Jean Fraser - Planner
City of Portland
Planning & Urban Development Department
389 Congress Street
Portland, ME 04101

January 17, 2014

Subject: Munjoy Heights
 Final Level III Site Plan – Conditions of Approval
 Comment Response Letter

CONSTRUCTION CONTROL

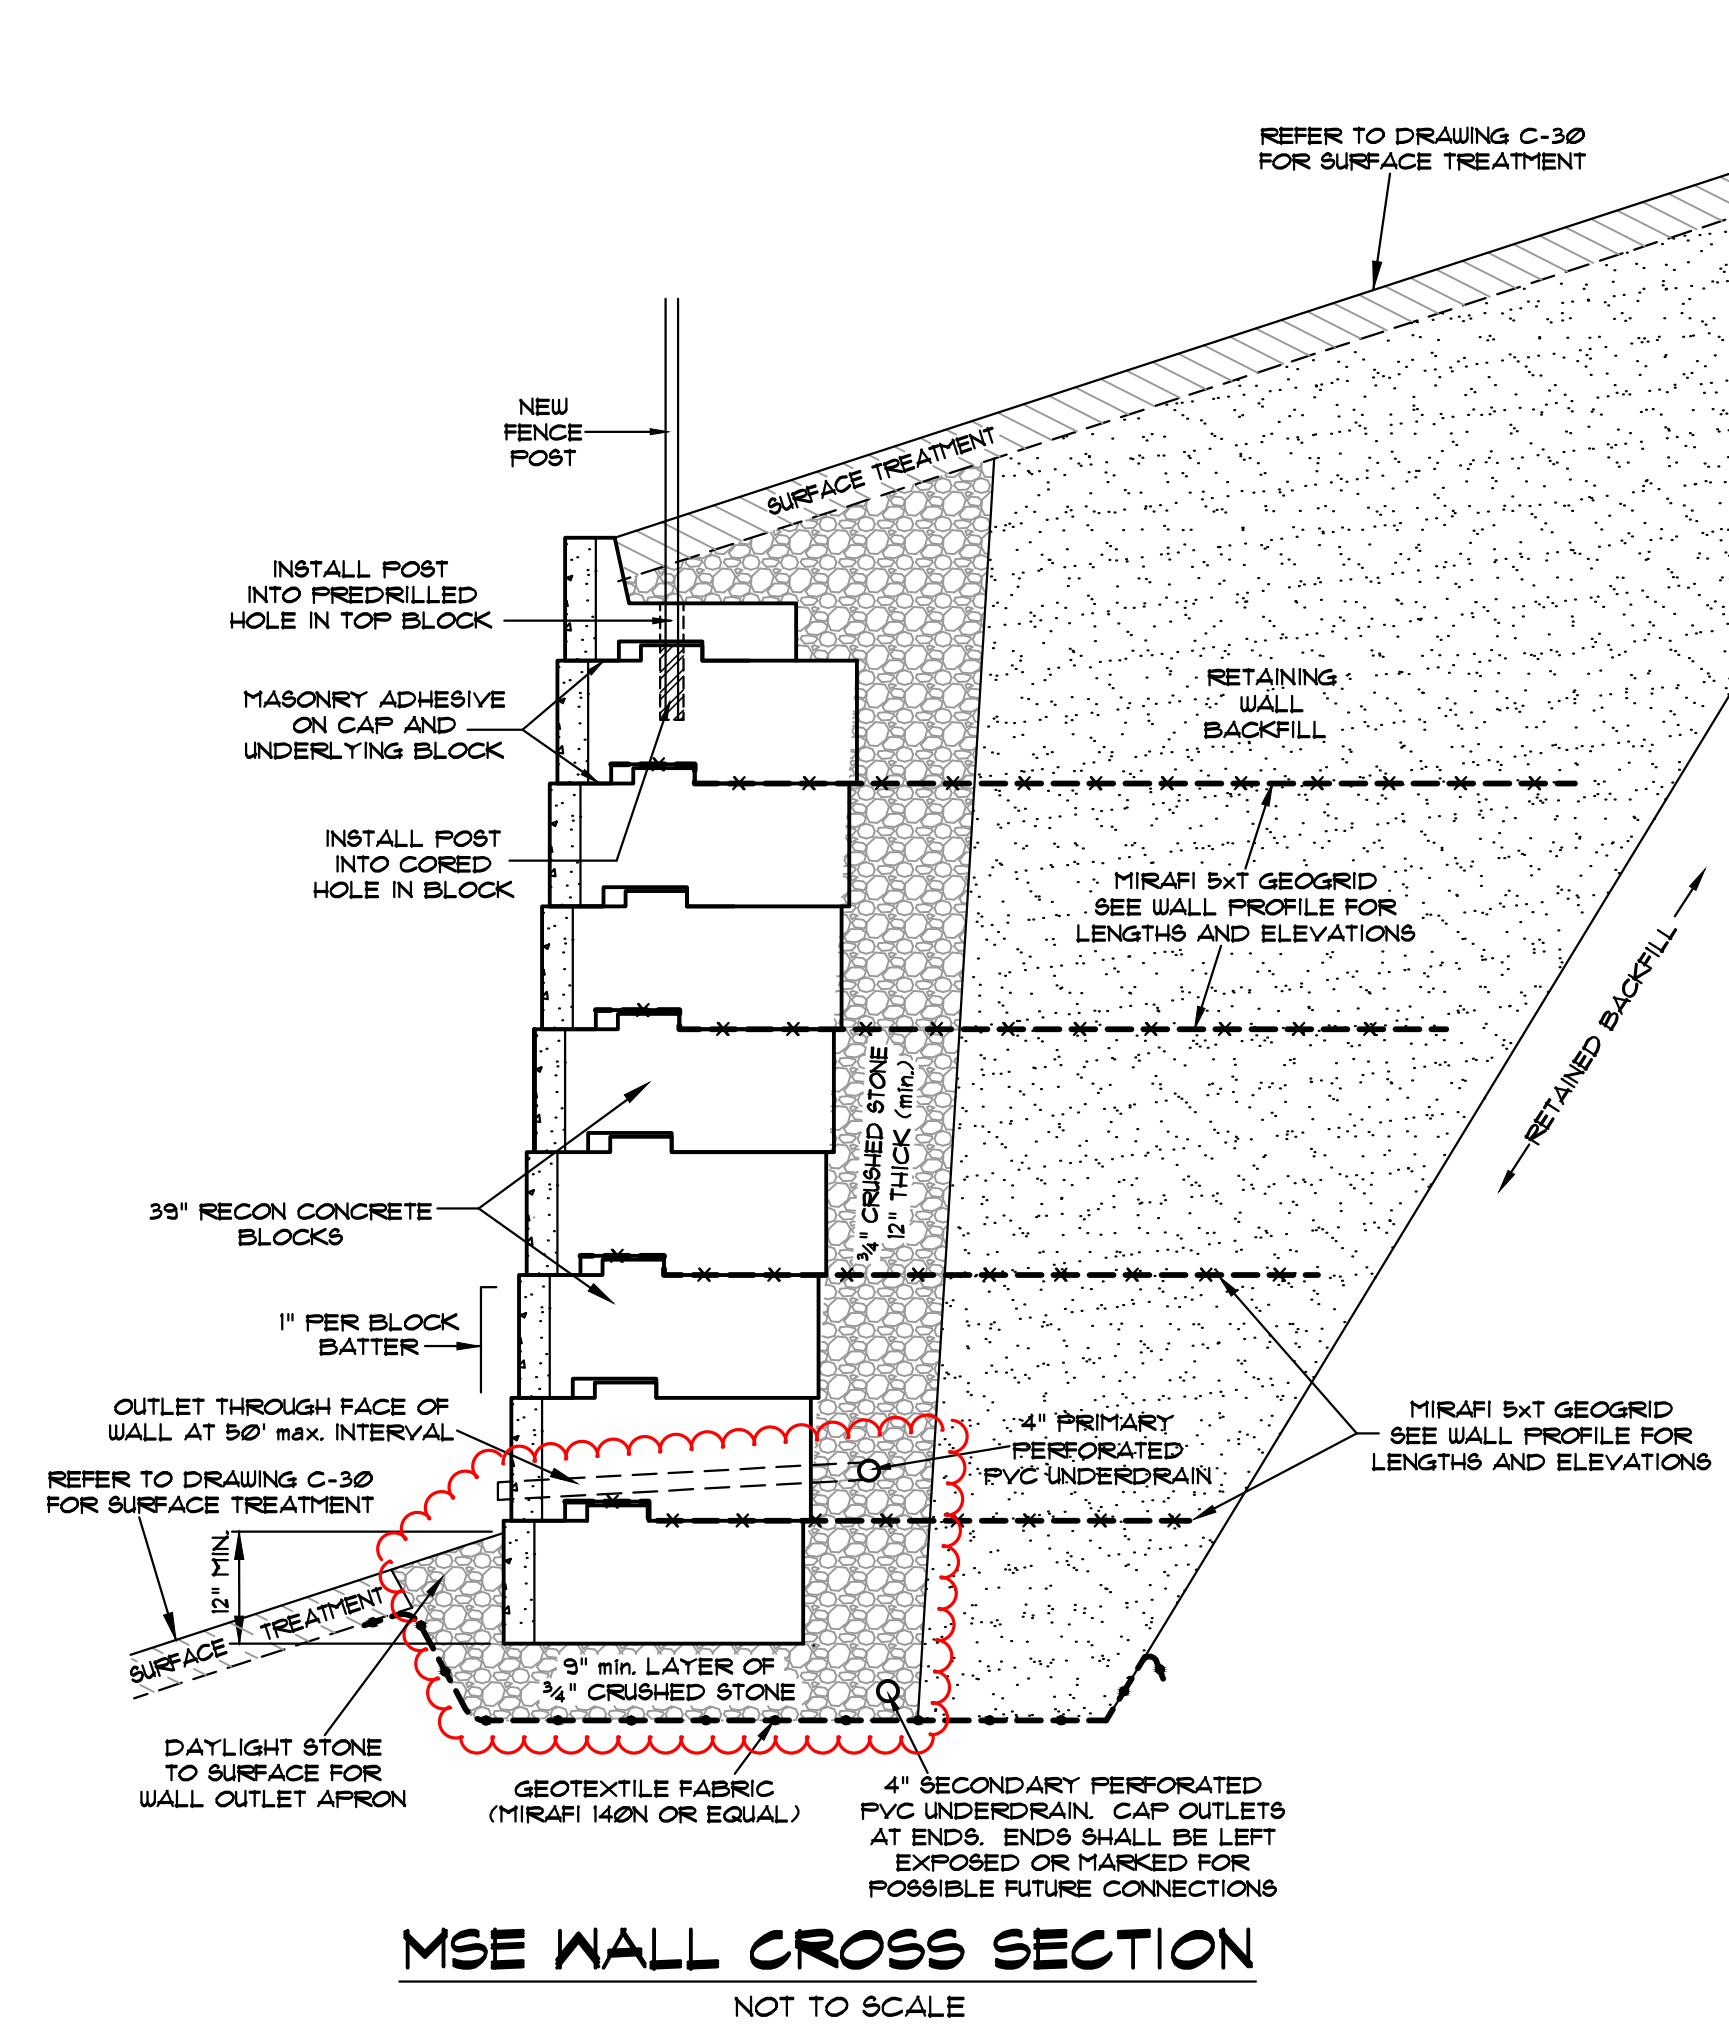
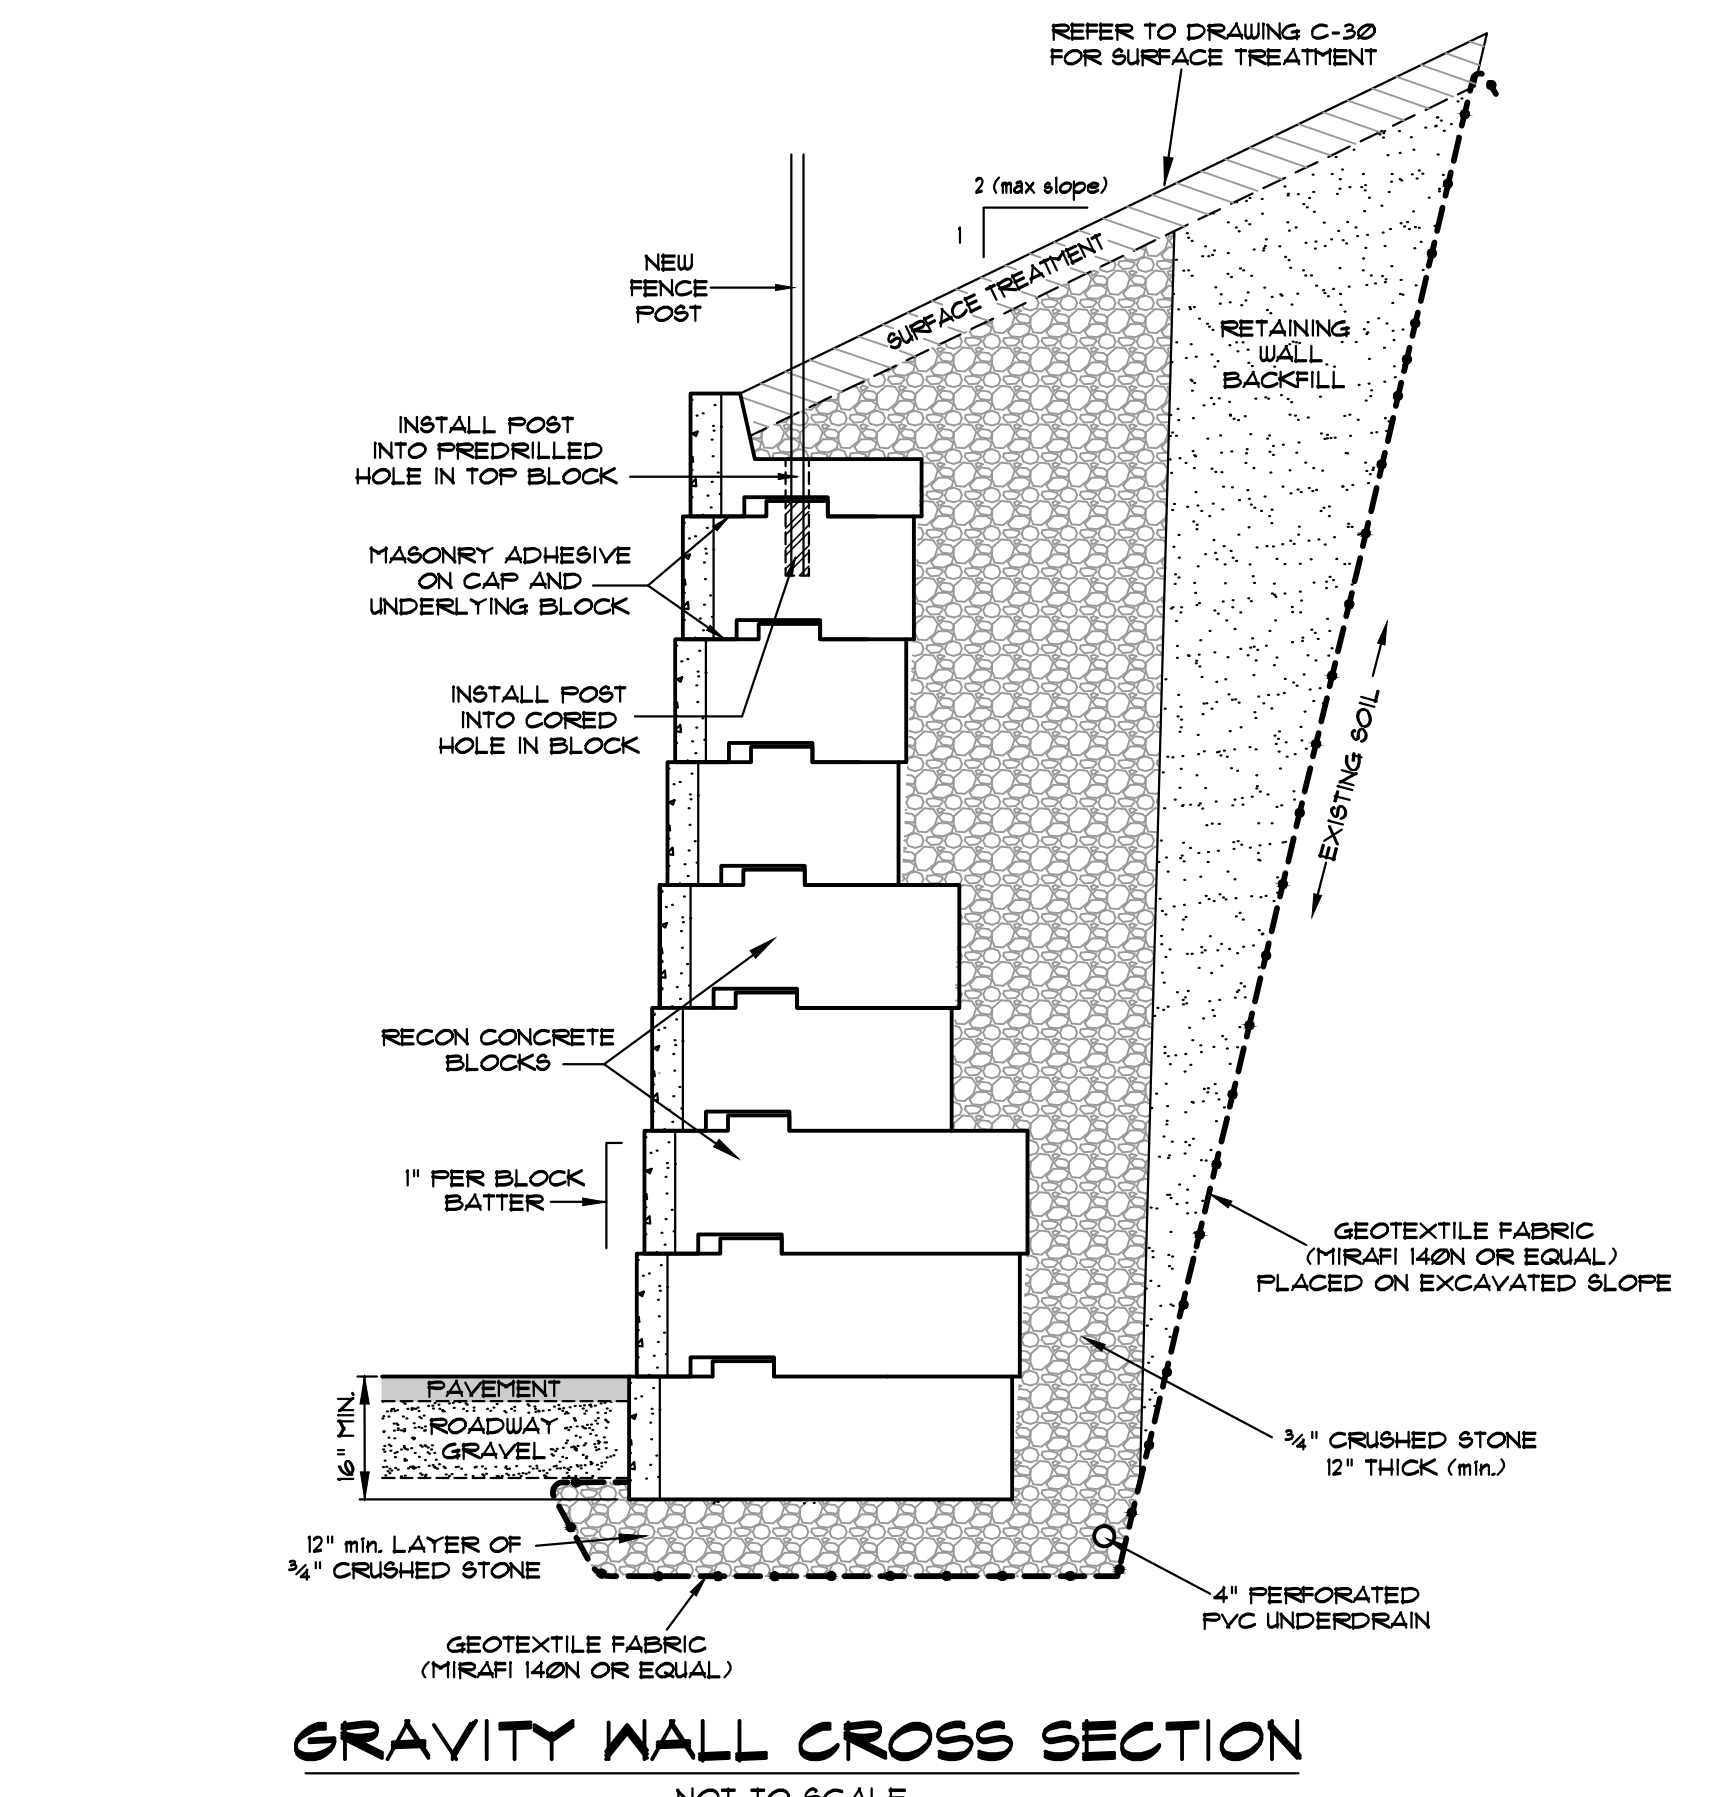
19) *In general we agree with the Applicant's proposal to provide "weep holes" at the base of the wall in lieu of a direct connection to the combined sewer in East Cove Street. The Applicant should include details and notes on the plans for the weep hole outlets to ensure that they are properly stabilized and that they do not direct concentrated flow onto adjoining properties. Per discussions with City DPS, the Applicant should design the retaining wall drainage system and weep holes to allow for a future connection to a hard-piped system if issues arise from groundwater flow. Additional notes and design details should be submitted for review and approval.*

#19: The following minor revisions were made to Sheet 3 of the SGS retaining wall drawings.

1) The crushed stone at the base of the wall is extended up to the ground surface in front of the wall to provide erosion protection. The concept is that the water flow out of the weep pipe, into the stone, and then percolates into the subgrade soil. This potential infusion of water into the stone base will not affect the integrity of the retaining wall.

2) A secondary underdrain is shown at the base of the crushed stone column behind the wall. This underdrain would be capped at its ends. If there is a problem with weep water flowing onto the adjacent property, the weep pipe outlets can be capped and the end of the secondary underdrain connected to the combined Sewer in East Cove Street.

DRAWING NO.
C-10

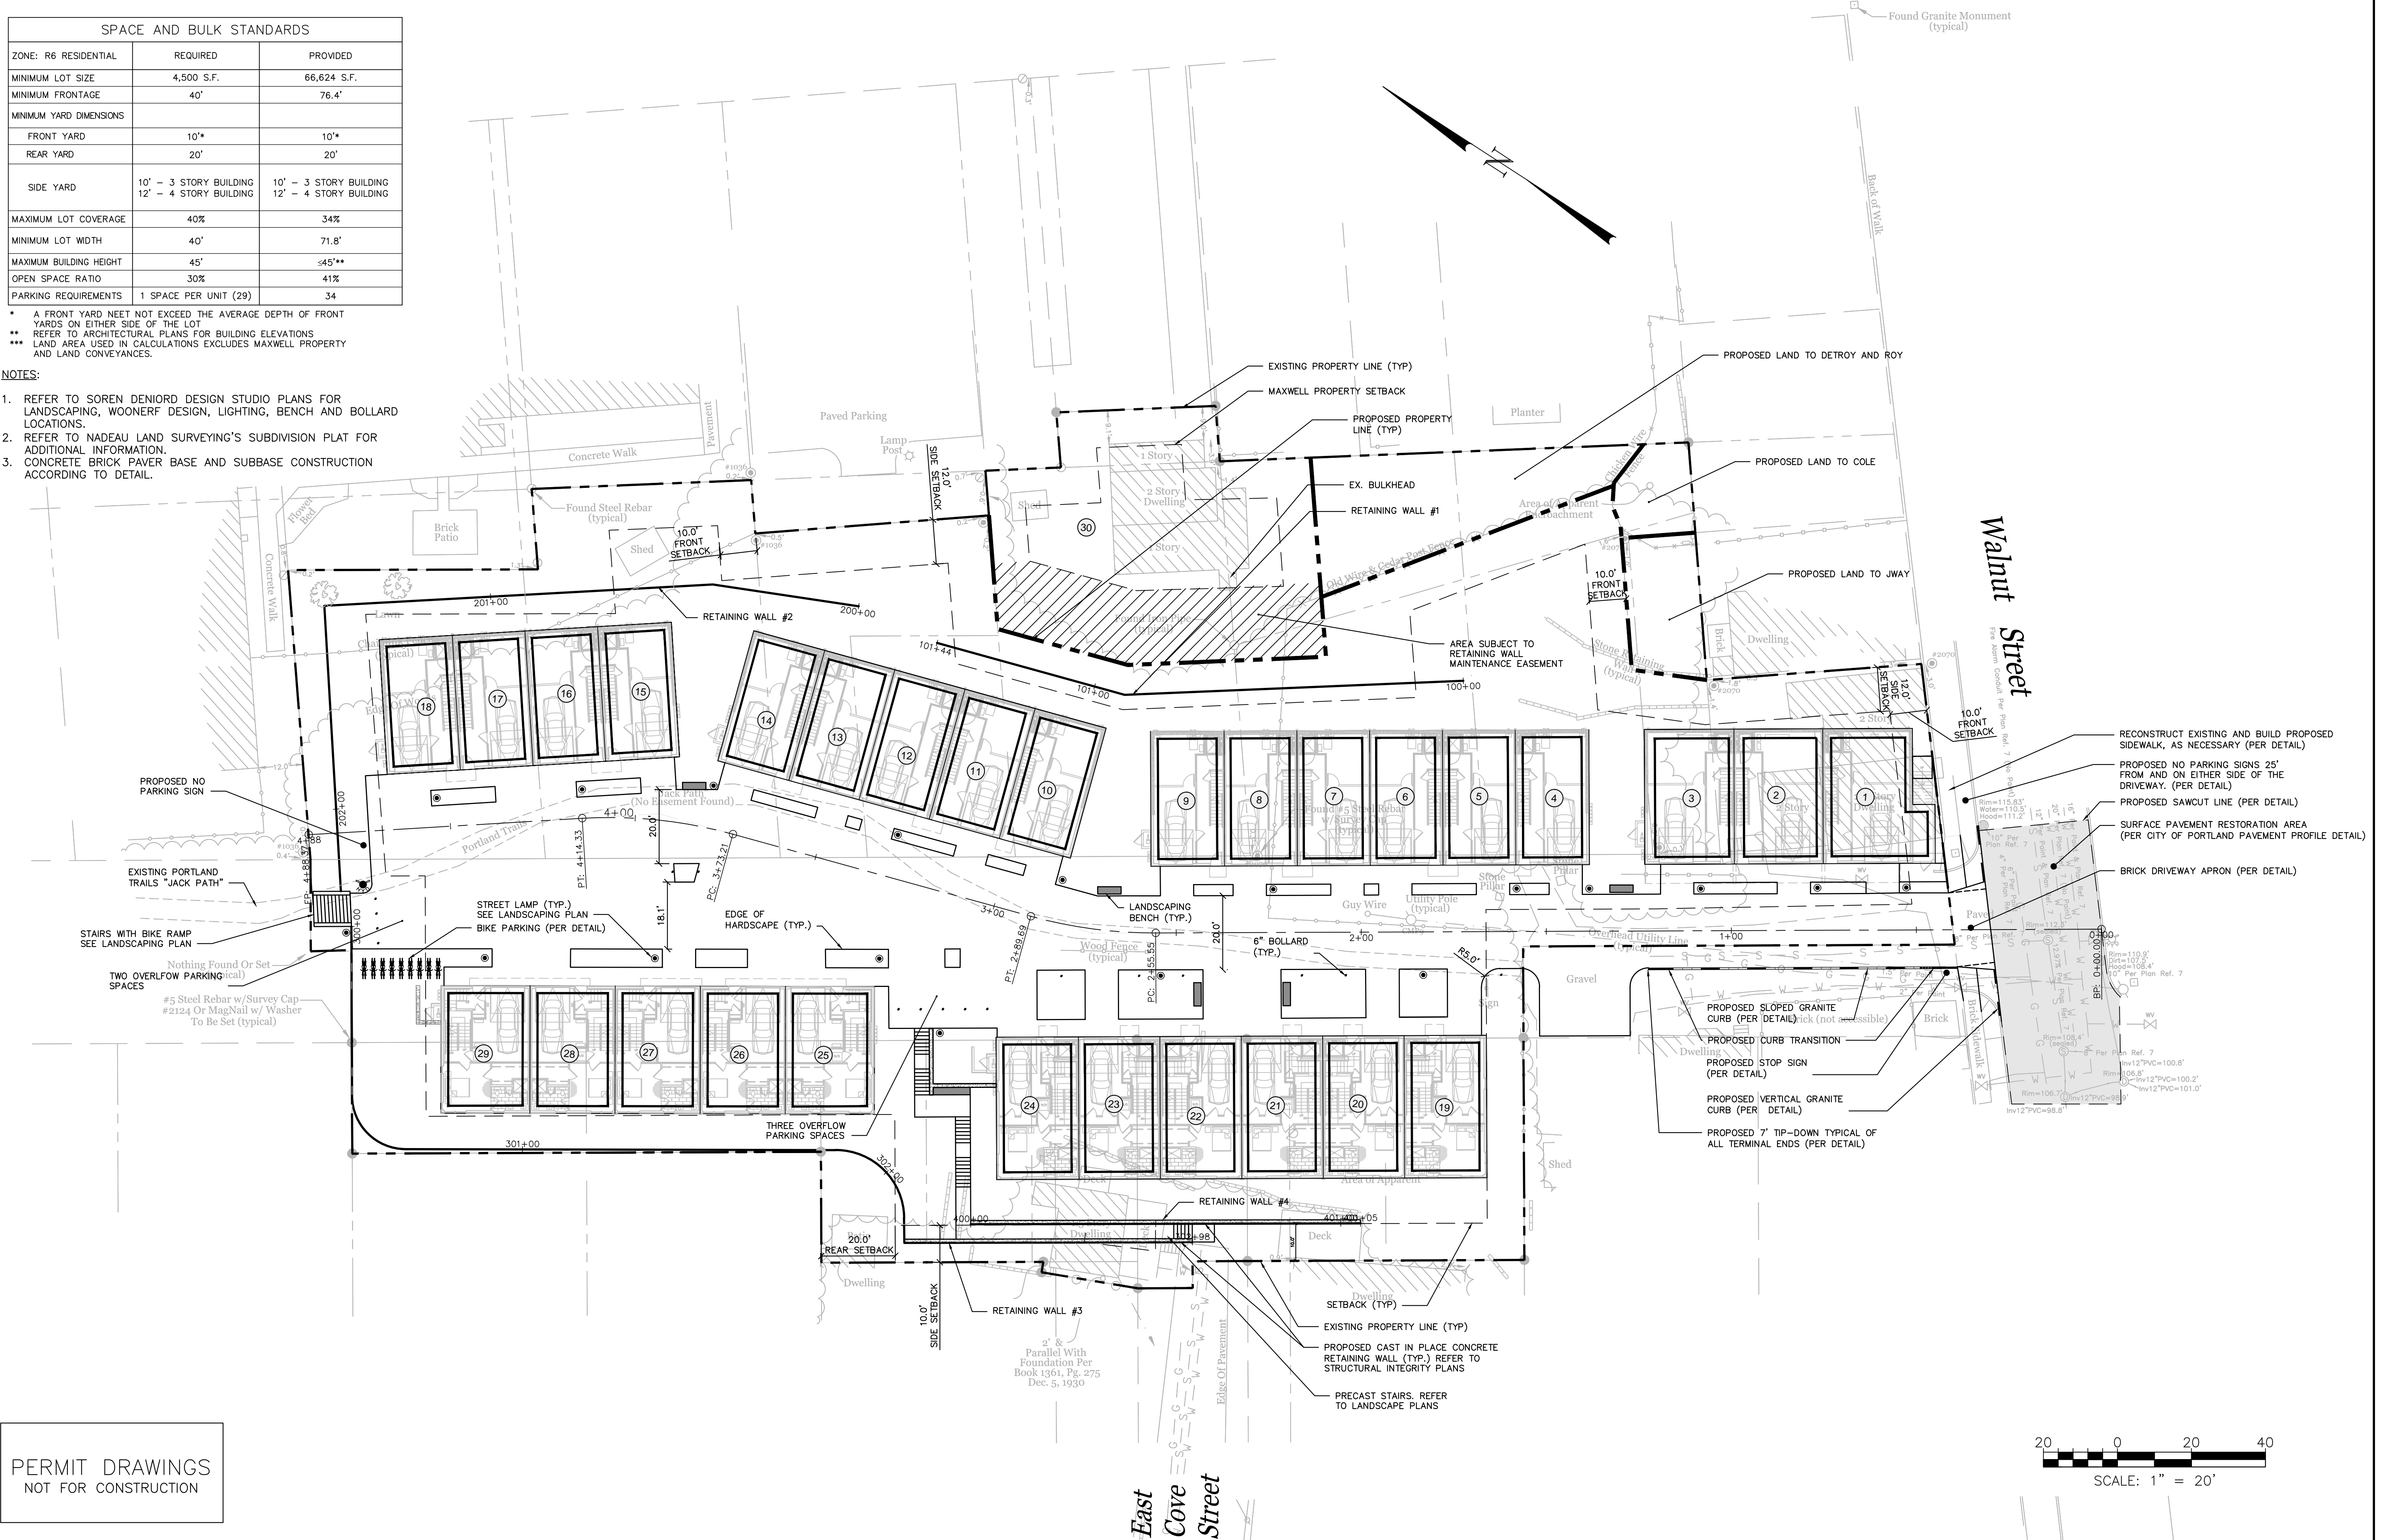
Comment 3 and 5

Response: On Sheet C-10, the driveway entrance radii was eliminated from the plans and standard tip-down curbing is provided.
